SAN JOSÉ CITY COLLEGE FACILITIES MASTER PLAN

Response to Comments Document

Prepared for
San José Evergreen Community College
District

September 2021

Figure 2
Site Plan

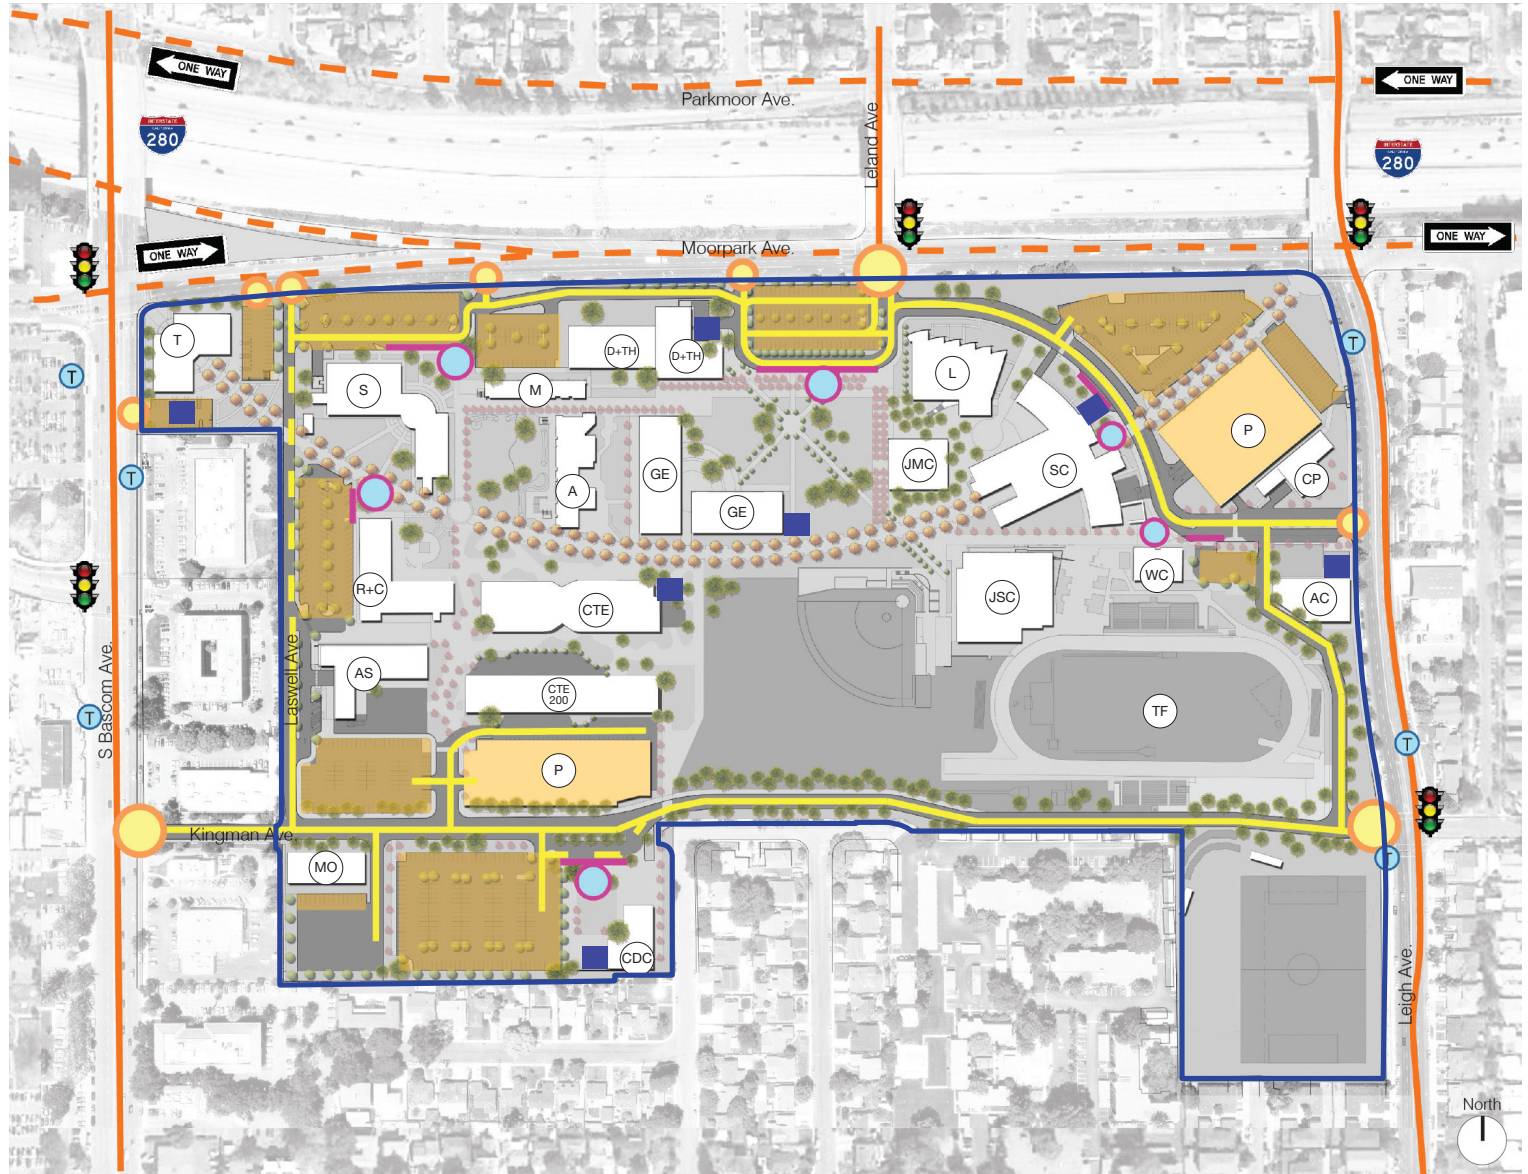
Draft EIR, Appendix E, Transportation Analysis, page 9, Figure 2: Site Plan, has been updated in response to comments (please see revised figure on following page).

Figure 2-5 does not identify any bike parking locations. VTA recommends updating the map to identify locations mentioned in the Bicycle Parking section on page 2-17. The DEIR and Appendix E make references to new installed bike parking near high use building. It is unclear from the Transportation Impact Analysis what volume of pedestrian or bicycle activity would determine where this parking should be located. VTA recommends additional study to determine parking locations for bike based on circulation and use. SJCC should also consider a centrally located bike parking hub which could serve the whole campus.

- Provide an updated site plan
- Include the following sections from the EIR’s Transportation section into this report:
 - Additional Access Improvements
 - Perimeter Loop
 - Student Drop-Offs
- Include the following Figure with the on-site circulation sections from above:

- B-7 The commenter indicates Figure 2-5 in the SJCC FMP Draft EIR does not identify any bike parking locations that are referenced on Draft EIR page 2-17. In response to this comment, Figure 2-5 has been updated to show the preliminary proposed locations for on-campus bicycle parking. In addition, Figure 2: Site Plan in the Traffic Analysis in the SJCC Draft EIR Appendix E has been replaced with this same revised figure. Please refer to Chapter 2, *Revisions to the Draft EIR*, for the revised Figure 2-5 from the Draft EIR Project Description, and revised Figure 2 from the Traffic Analysis in Appendix E of the SJCC Draft EIR.

- C-1 The commenter requests the Transportation Analysis in Appendix E in the SJCC FMP Draft EIR include an updated site plan. Figure 2 in the Transportation Analysis in Appendix E has been replaced with the same project site access and circulation plan included as Figure 2-5 in Chapter 2 of the Draft EIR, *Project Description*. Furthermore, this figure has been updated to reflect other proposed SJCC campus transportation improvements. Please refer to Chapter 2, *Revisions to the Draft EIR*, for the revised Figure 2-5 from the Chapter 2 of the Draft EIR, and revised Figure 2 from the Traffic Analysis in Appendix E of the Draft EIR.
